### CERTIFICATE OF APPROPRIATENESS

**Property:** 2047 W Gray Street #A, Tracks 10, 11, 12, & 13A, Abst 696 O Smith. The commercial property includes the historic River Oaks Theatre and the River Oaks Community Shopping Center.

**Proposal:** Alteration – Storefront and Patio

FRONT (WEST) ELEVATION

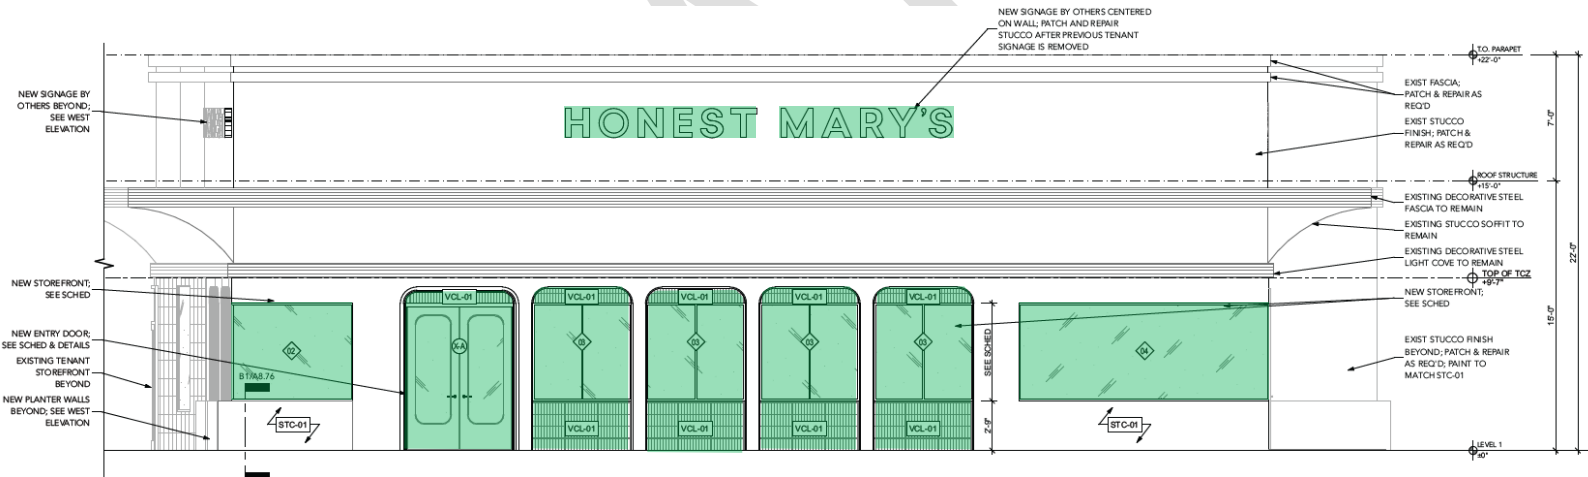
Applicant is proposing alterations to existing storefront for new tenant, Honest Mary's.

- Removal and replacement of existing non-bearing storefront system and entry doors
- Removal and replacement of signage with reverse channel LED halo-illuminated signage
- Installation of skylight; existing roofing membrane to remain
- **ALL NEW WINDOWS MUST BE INSET 1¼ Inches – See Attachment 1**
- **Windows Must Be Equally Horizontally Divided 1-over-1**
